ST. LUCIE PLANT UNIT 1 AND UNIT 2

IMPROVED TECHNICAL SPECIFICATIONS CONVERSION

ITS CHAPTER 4.0 DESIGN FEATURES

Current Technical Specifications (CTS) Markup and Discussion of Changes (DOCs)

St. Lucie – Unit 1

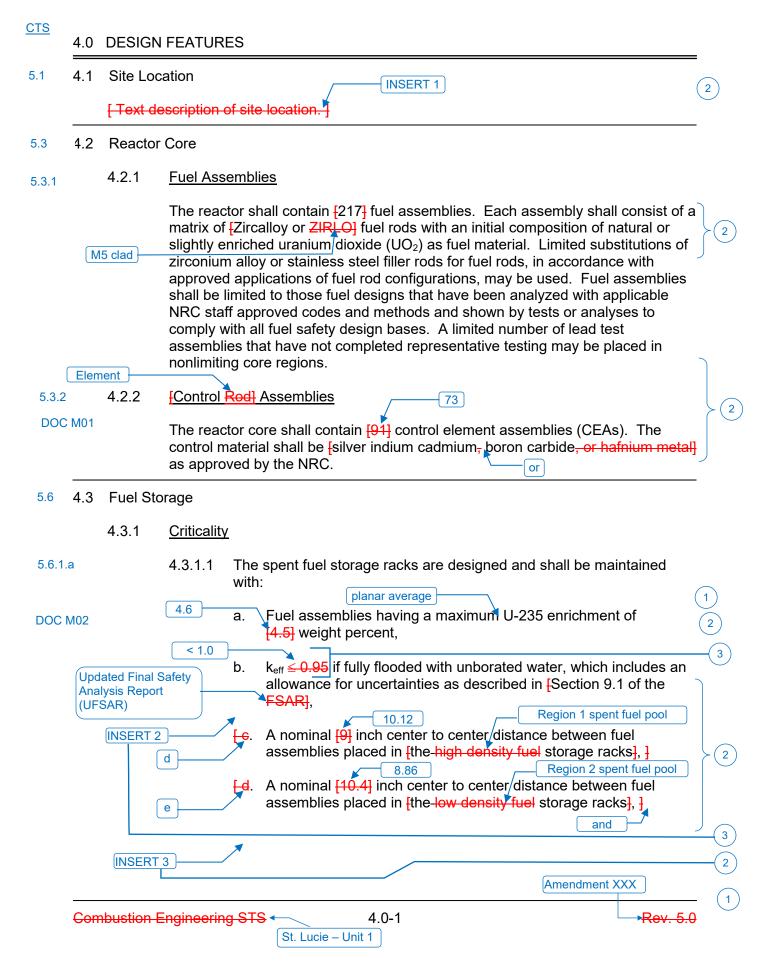
5.6.1.d		 4.3.1.2 The new fuel storage racks are designed and shall be maintained with: a. Fuel assemblies having a maximum U-235 enrichment of 4.6 → [4.5] weight percent,

5.6.1.d DOC M		 b. k_{eff} ≤ 0.98 if fully flooded with unborated water, which includes an allowance for uncertainties as described in [Section 9.1 of the U → FSAR],

c. k_{eff} ≤ 0.98 if moderated by aqueous foam, which includes an allowance for uncertainties as described in FSAR, and
DOC	VI02	d. A nominal 10 inch center to center distance between fuel assemblies placed in the storage racks.

5.6.2	4.3.2	Drainage
		The spent fuel storage pool is designed and shall be maintained to prevent inadvertent draining of the pool below elevation [23 ft].

5.6.3	4.3.3	Capacity and cask pit are total (1)
		The spent fuel storage pool <mark>vis</mark> designed and shall be maintained with a storage capacity limited to no more than [1542] fuel assemblies.
		1849
		with the spent fuel pool storage racks limited to no more than 1706 fuel assemblies and the cask pit storage rack limited to no more than 143 fuel assemblies

St. Lucie – Unit 2

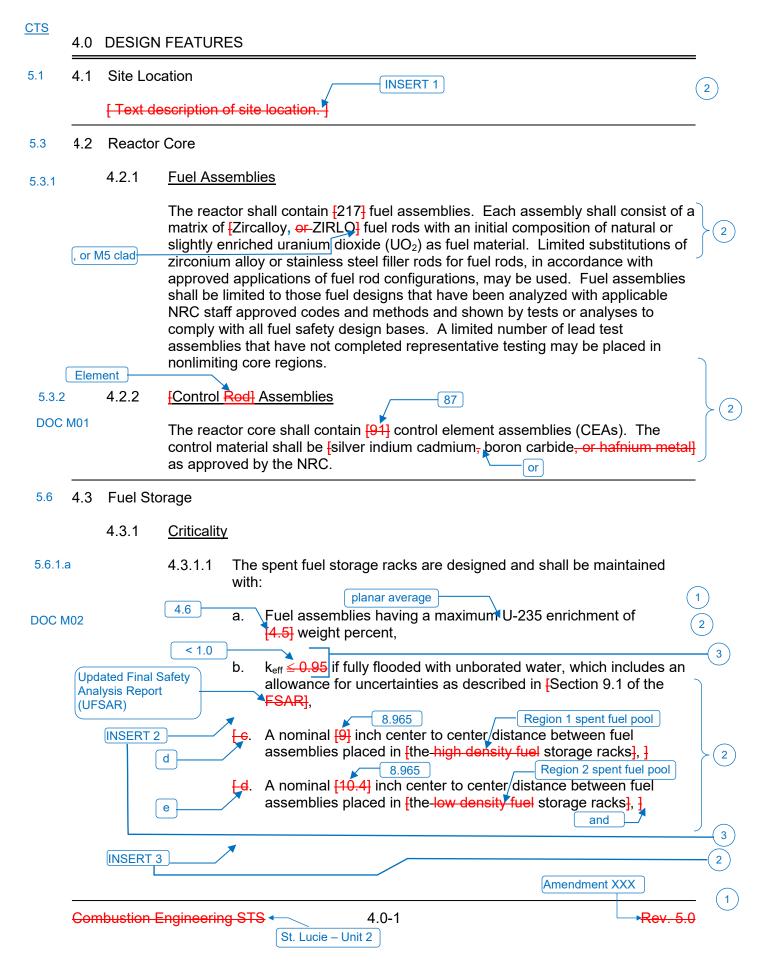
5.6.1.d		 4.3.1.2 The new fuel storage racks are designed and shall be maintained with: a. Fuel assemblies having a maximum U-235 enrichment of 4.6 → [4.5] weight percent,

5.6.1.d DOC M02		 b. k_{eff} ≤ 0.98 if fully flooded with unborated water, which includes an allowance for uncertainties as described in [Section 9.1 of the U → FSAR],

5.6.1.d DOC M02		 c. k_{eff} ≤ 0.98 if moderated by aqueous foam, which includes an allowance for uncertainties as described in [Section 9.1 of the U→FSAR], and 	
DOC M02		d. A nominal [10] inch center to center distance between fuel assemblies placed in the storage racks.

5.6.2	4.3.2	Drainage 56	
		The spent fuel storage pool is designed and shall be maintained to prevent inadvertent draining of the pool below elevation [23 ft].

5.6.3	4.3.3	Capacity and cask pit are total 1	
		The spent fuel storage poor is designed and shall be maintained with a storage capacity limited to no more than [1542] fuel assemblies.	
		1716	
		with the spent fuel pool storage racks limited to no more than 1491 fuel assemblies and the cask pit storage rack limited to no more than 225 fuel assemblies
